MEMORANDUM

SUBJECT: BZA No. 14096A -- Request for Special Exception Modification of Previous BZA Order Under 11 DCMR § 768 -- 529 14th St., NW – Square 254, Lot 53

Figures 3a, 3b, 3c, 3d. Areas of Proposed Infill of Atrium

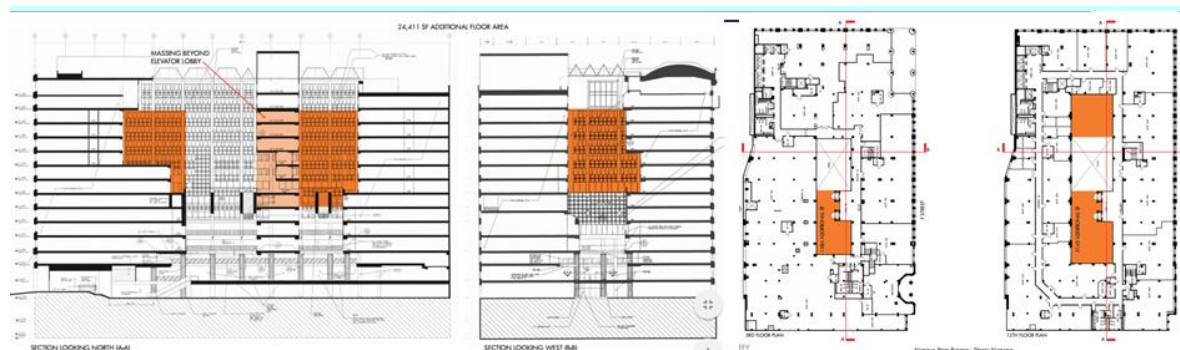
The new space would fill-in the eastern and western portions of the existing enclosed atrium illustrated in Figure 2. The locations of the proposed additions are shown below in orange in Figure 3, as follows:

3a: East-West Section. Central part of the atrium would remain open through all floors; entire atrium would remain open for top two floors.

3b: North-South Section. Additions in eastern 3rd to 12th floor of atrium.

3c: Plan of Third Floor: Western part of atrium filled-in one floor deeper than eastern part.

3d: Typical Plan, floors 3 – 12: Central portion of atrium remains open.
